ZONING CHANGE REVIEW SHEET

CASE: C814-89-0003.02 – 305 S. Congress PUD DISTRICT: 9

ZONING FROM: PUD-NP TO: PUD-NP, to change conditions of zoning

Street Sections and Internal Private Driveway Typical Sections

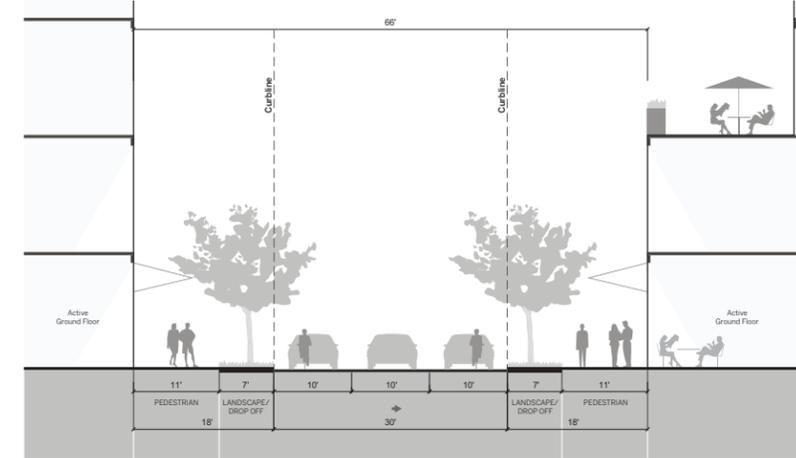
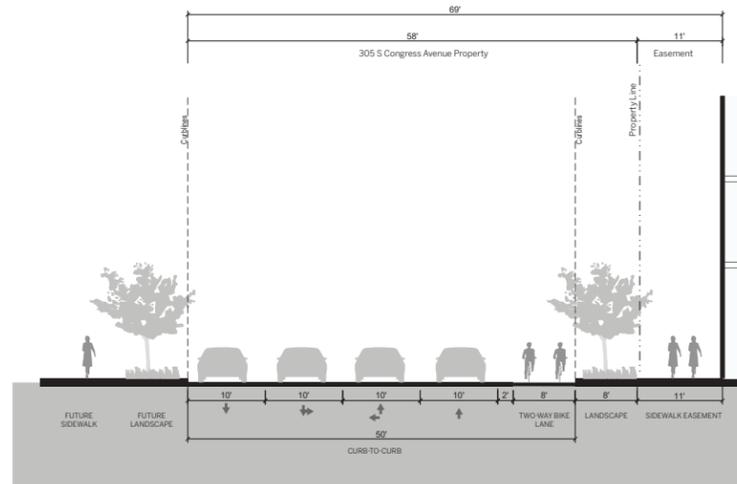
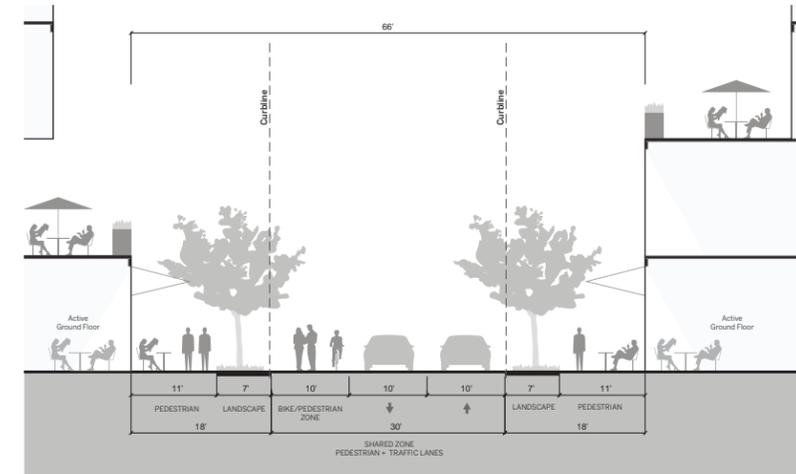
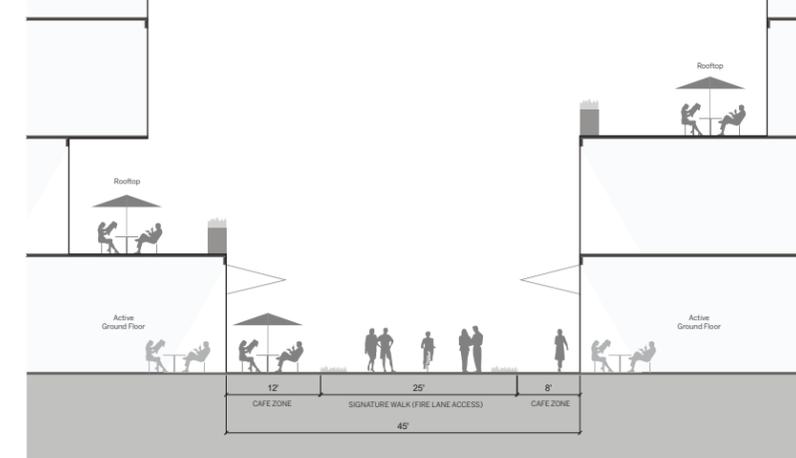
- Barton Springs Road extension shall be considered an Urban Roadway for the purposes of complying with Chapter 25-2, Subchapter E – Design Standards and Mixed Use, and will be designed in accordance with the PUD street sections located on Sheet 4.

- **TCM Table 5-2 (*Type II Commercial Driveway Criteria*) is modified to allow the construction of the driveways to adhere to the cross-sections within the PUD.**
 - a. **Not recommended by staff.**

Setbacks and Land Use Map

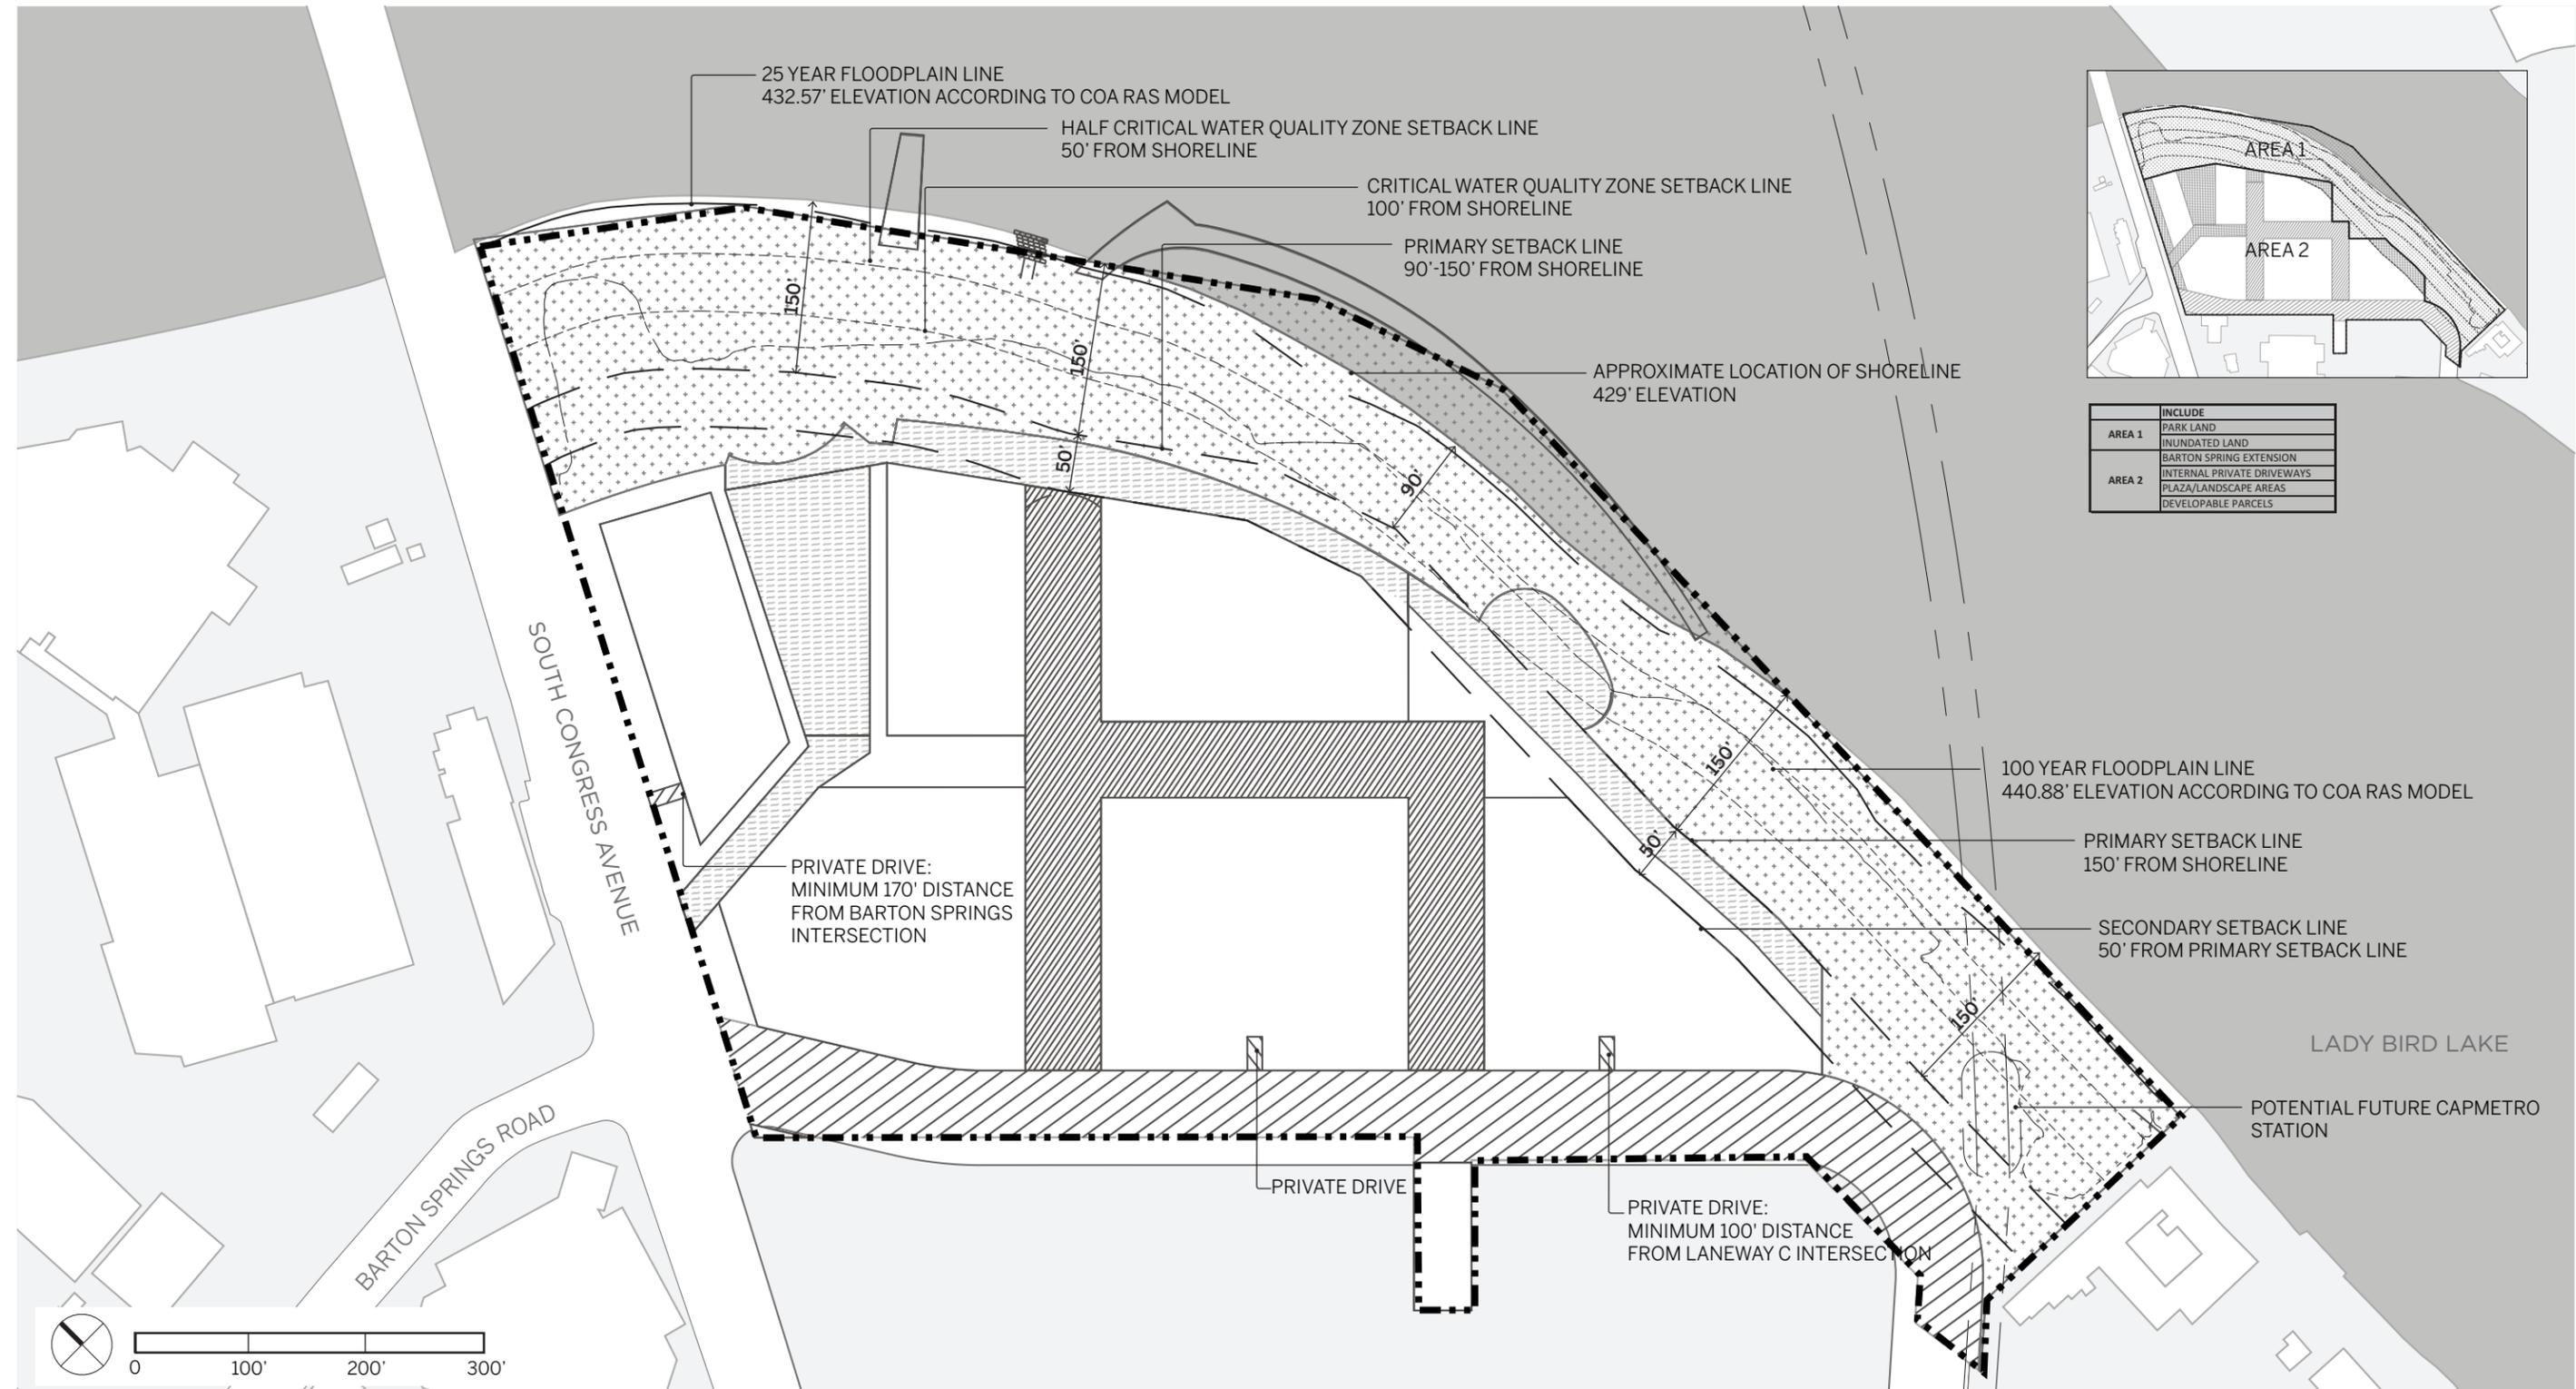
- a. Recommended by staff.
- Section 25-2-721(B)(2) (*Waterfront Overlay (WO) Combining District Regulations*) is modified to allow uses within Area 1, identified on the Setback and Land Use Map, to be consistent with the current allowable uses in the Public Zoning District.

- a. Recommended by staff.
- Sections 25-2-742(B)(1) (*South Shore Central Subdistrict Regulations*) is modified to reduce the primary setback line to 90 feet landward from the shoreline as shown on the Land Use Plan.
